Re: Orchard Hills Waste and Resource Management Facility – Supplementary Noise Assessment.

Additional Information

Responses to Ministers and Council Questions

**Orchard Hills Waste and Resource Management Facility
Penrith and Anor ats Dellara – Land and Environment Court Proceedings 10928 of 2011
Response to Request for additional information in relation to the Further Modified
Preferred Project Report (FMPPR)**

Figure A (amended)
INDICATIVE CONSTRUCTION
SEQUENCE FOR NORTHERN FACE
21 September 2011

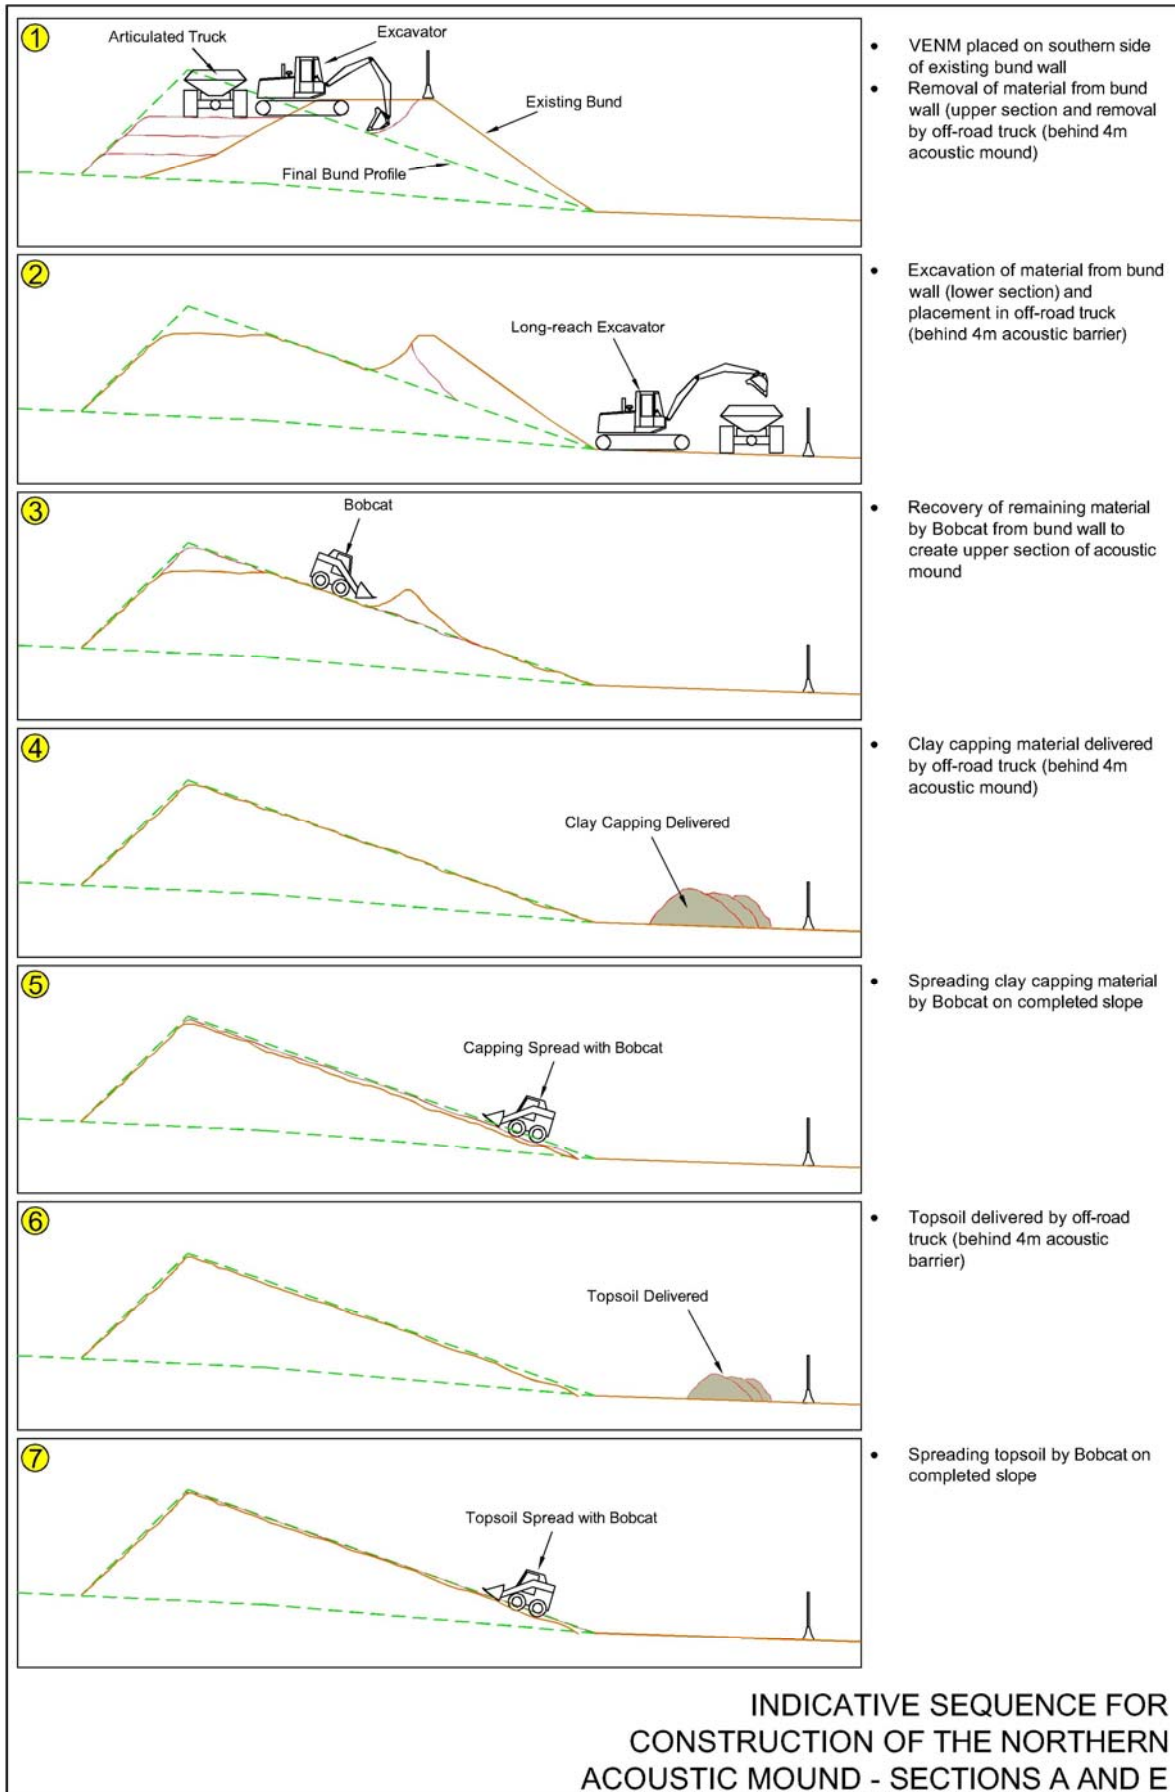
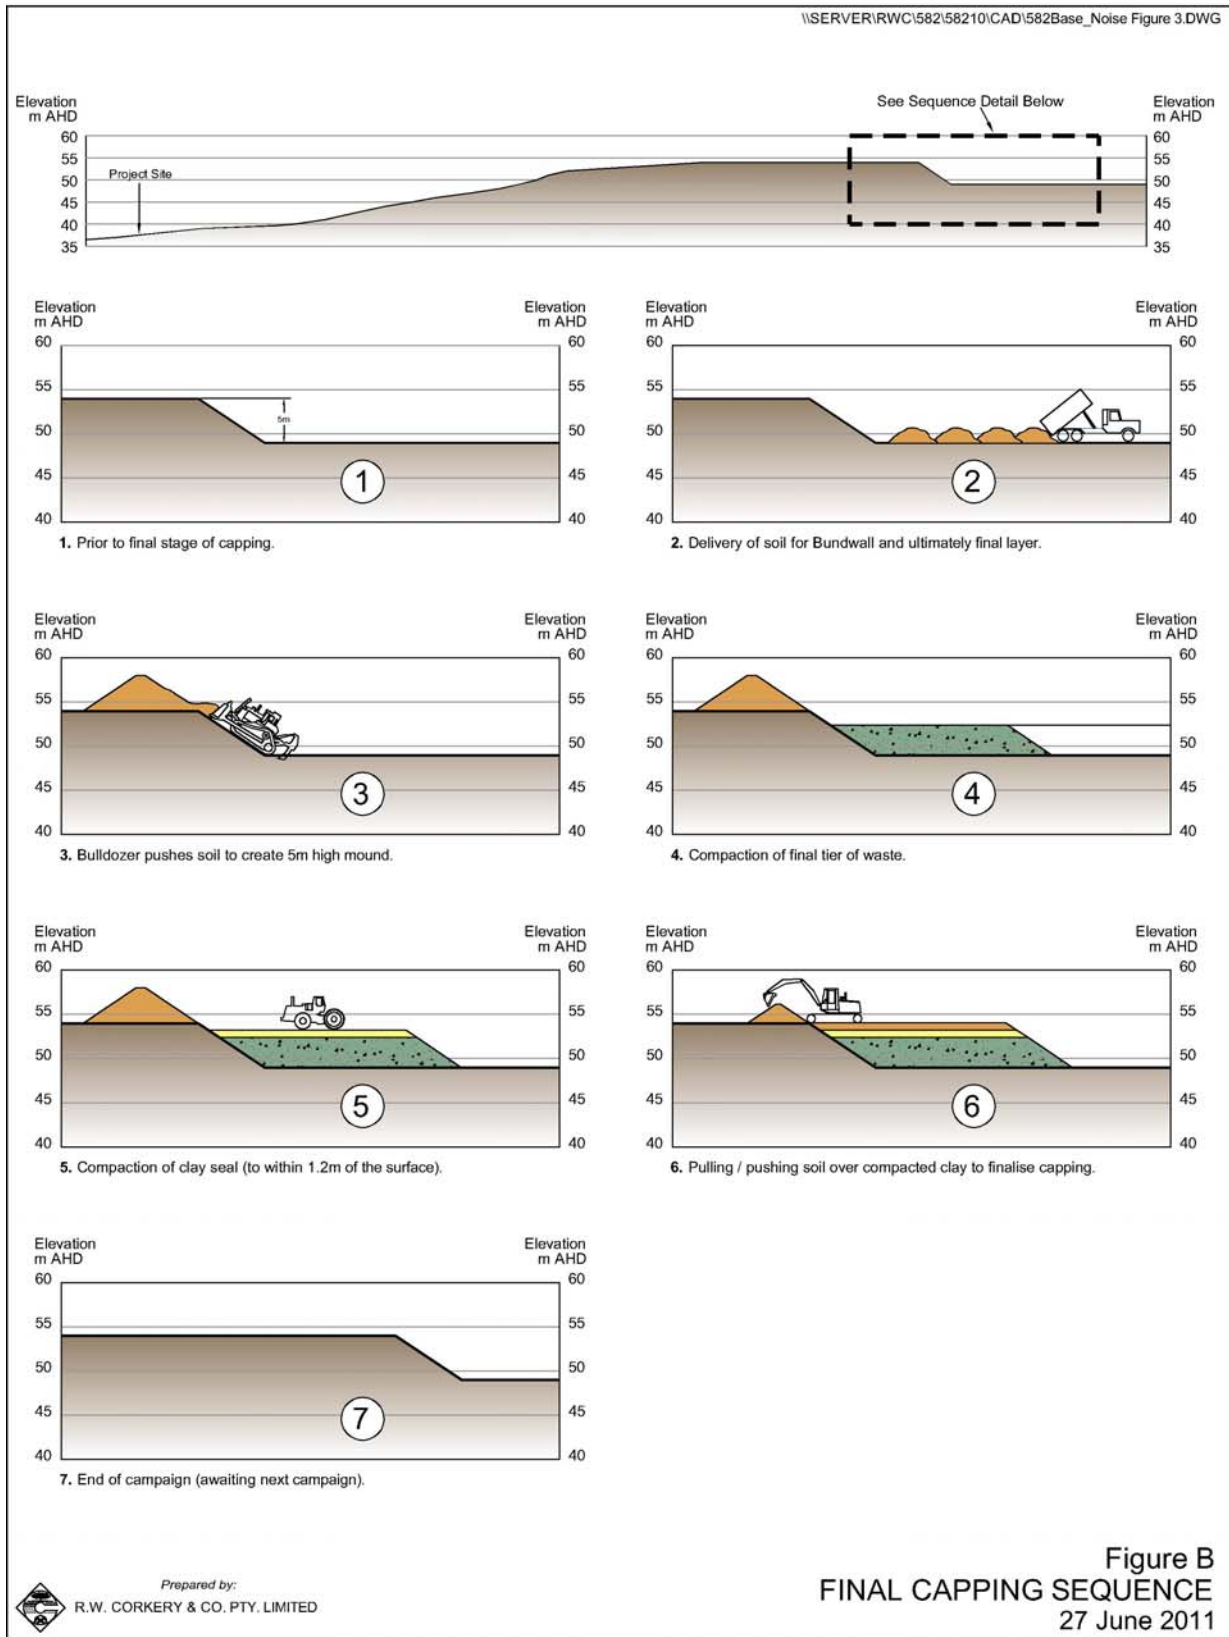
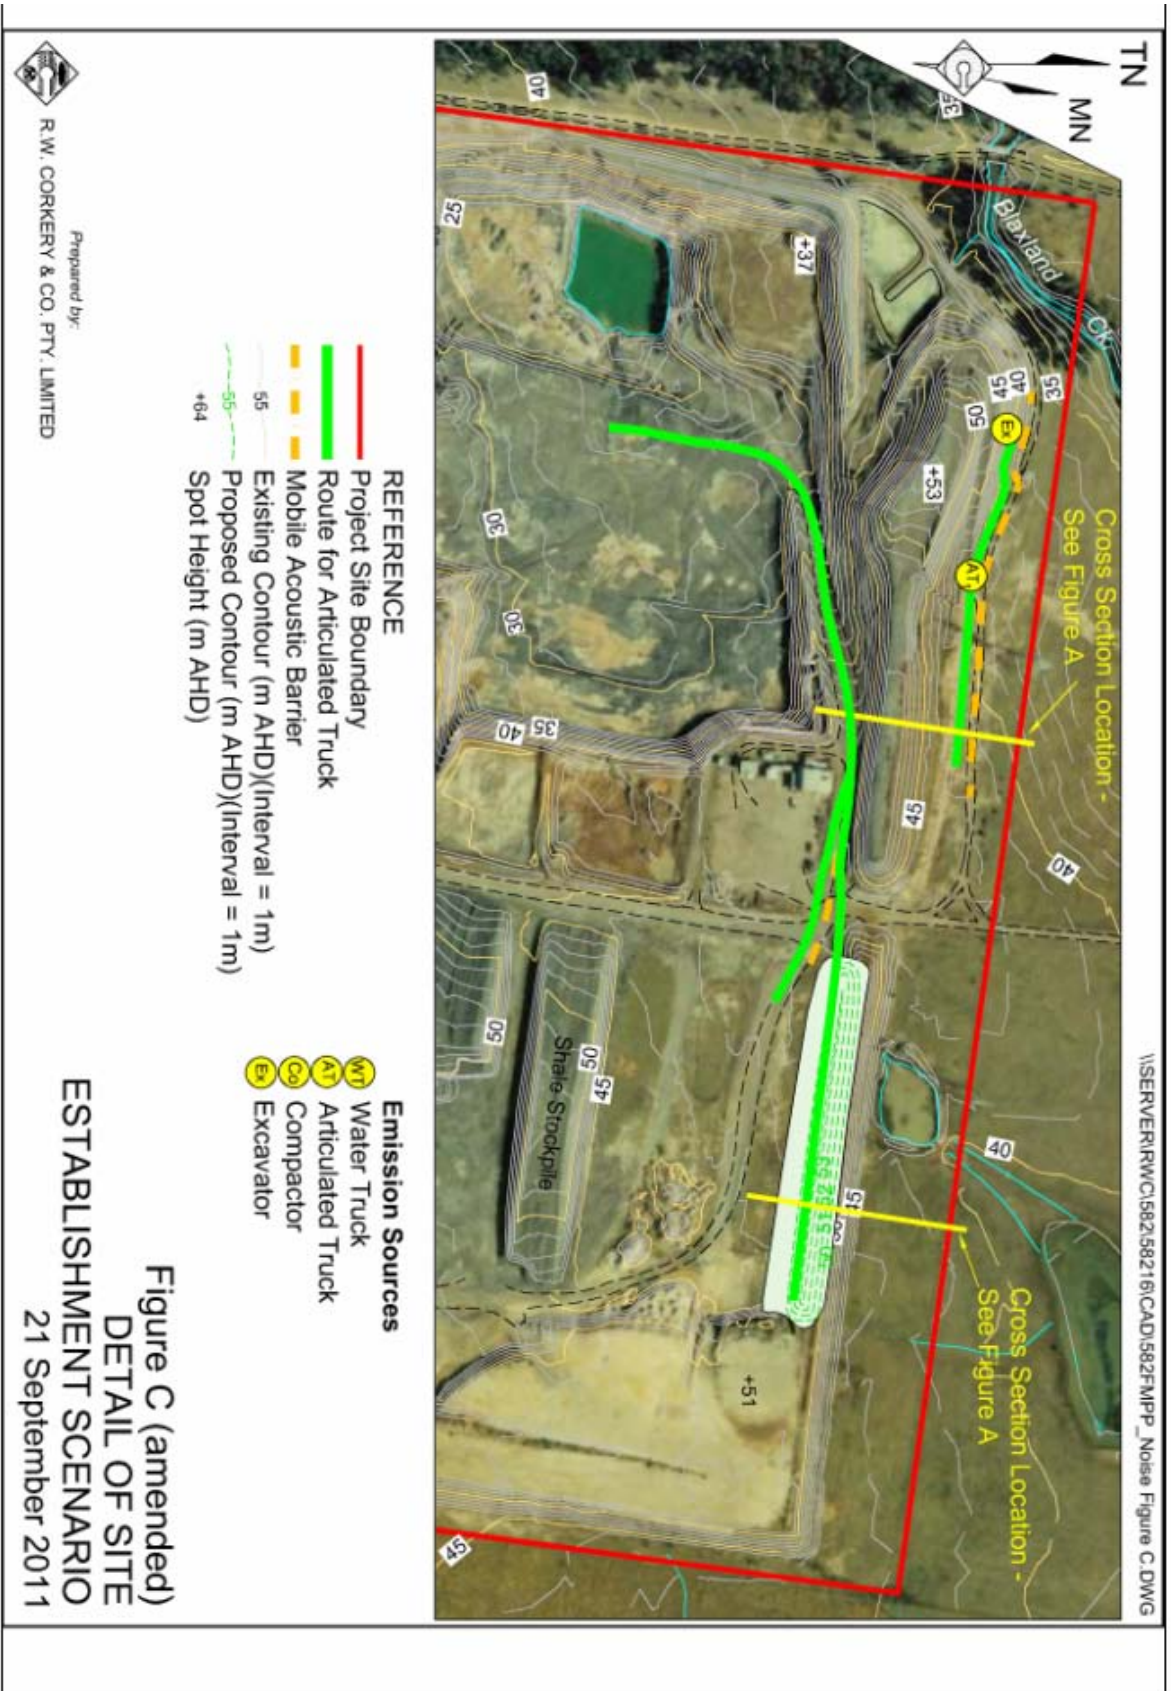
Detailed staging diagrams and explanations of the moveable barriers, central acoustic mound and southern acoustic mound.

- Figure A (Amended) – Showing revised sections across the northern mound (sourced from the Statement of Evidence of Dr Robert Bullen and the Joint Report).
- Indicative Sequence for Construction of the Northern Acoustic Mound Sections A and E – Prepared in response to Council’s request for additional information showing the construction process for the north eastern bund wall.
- Figure B Final Capping Sequence – (sourced from Statement of Evidence of Dr Robert Bullen)
- Figure C (Amended) – Detail of Site Establishment Scenario (sourced from the Statement of Evidence of Dr Robert Bullen).

These have been prepared to illustrate the methodology to be adopted to control noise emissions associated with construction works. Whilst the locations of the barriers and the topography change from previous assessments, the proposed methodology of barrier location and movements have not.

Figure CSA
CONTINGENCY STOCKPILE AREA

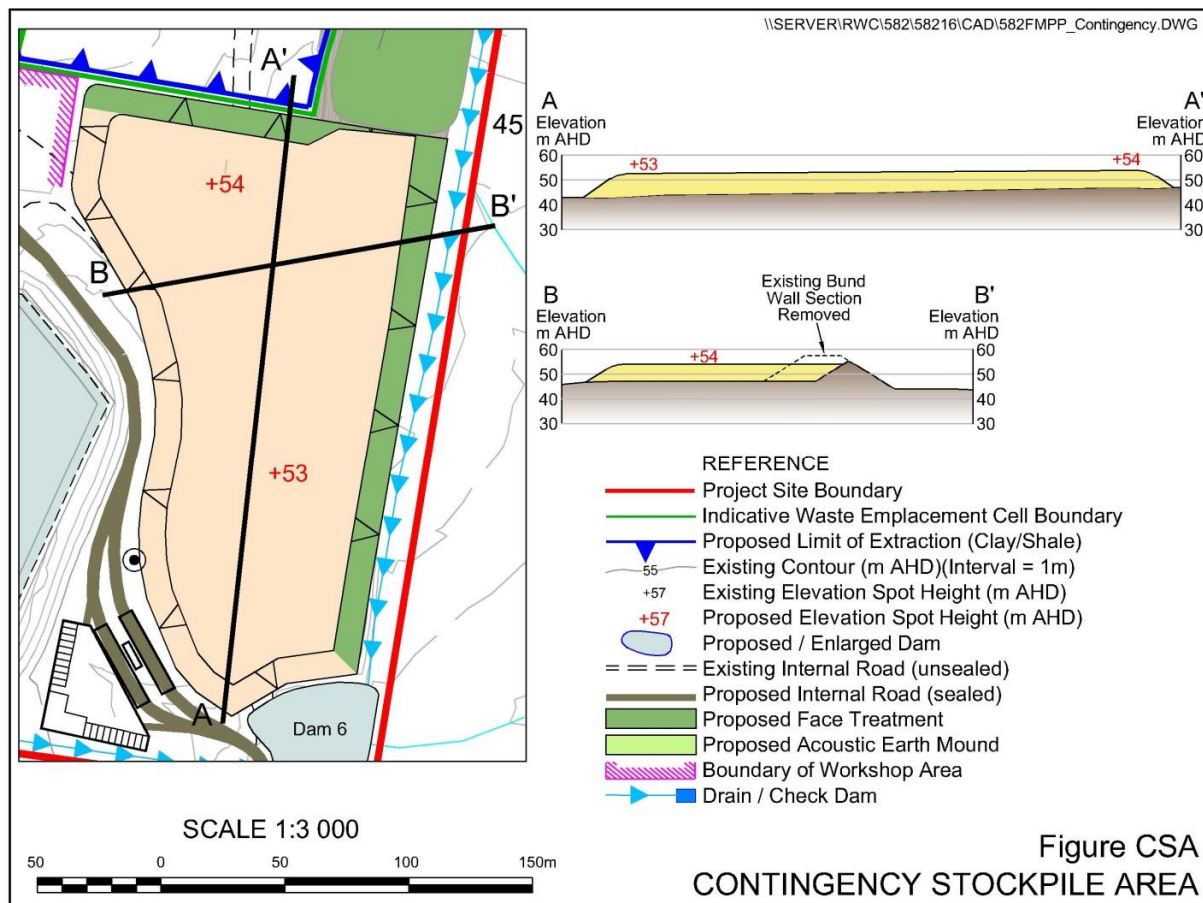
In respect of the proposed contingency stockpile, the information and documentation supplied provides inadequate details. Please provide details concerning the:

Figure CSA below provides a plan and sections of the contingency stockpile area.
